Date	December 18, 2025
Contact person	Daan van der Hoek
E-mail	D.C.vanderHoek@tudelft.nl
Subject	Response to reviewers

Reviewer #1, Reviewer #2
Wind Energy Science

Response to comments of Reviewer #1

Figure 1: Streamwise velocity in the wake of the MoWiTO at a downstream distance of $1D$. The black lines indicate the part of the wake that is considered in the analysis of Fig. 7 in the paper.

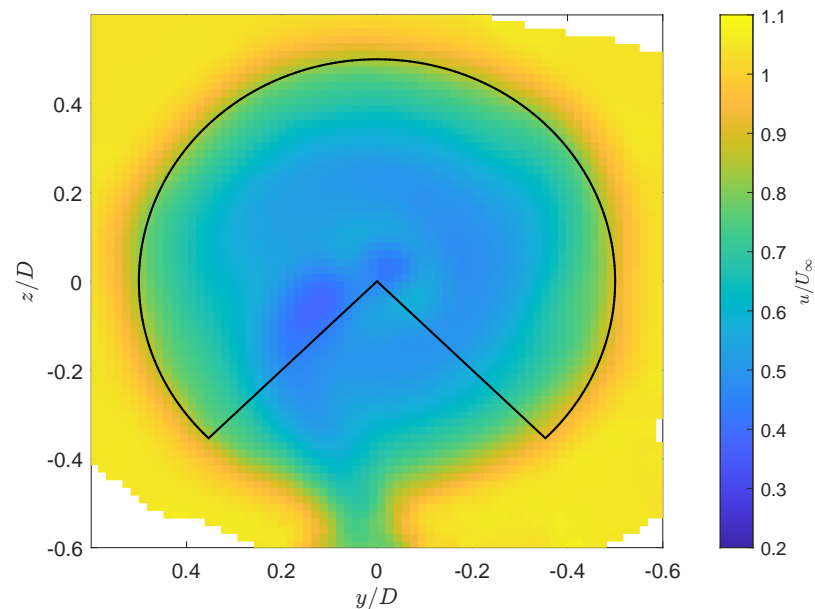
- Line 180: The reason why the lower part of the wake is neglected is understood. However, there is no discussion on how big is the sector that is left out (aperture angle), and why it was made this way. This is not a good practice, since it seems an arbitrary choice. Perhaps by comparing with older measurements, the impact of the hexapod could actually be quantified and accounted for. Or LES simulations could be used to clarify this point.
  This should indeed be mentioned in the text. A cross-section of the wake is given in Fig. 1 of this document. This figure shows the streamwise velocity at a distance of $1D$ downstream. In the bottom quarter of the wake, we can see the outline of the tower. The hexapod itself is located further down and is not visible in the plot. However, as a precaution, we decided to include only the area indicated in the figure in the analysis of Fig. 7 in the paper. The entire lower quarter, between $\theta = -45°$ and $\theta = 225°$, of the wake has been left out of the analysis. We have revised the text to clarify this point.

"Since the hexapod leaves a wind shadow below the wake, the bottom part of the wake (between $\theta = 45°$ and $\theta = 225°$) is not considered for this analysis as a precaution."
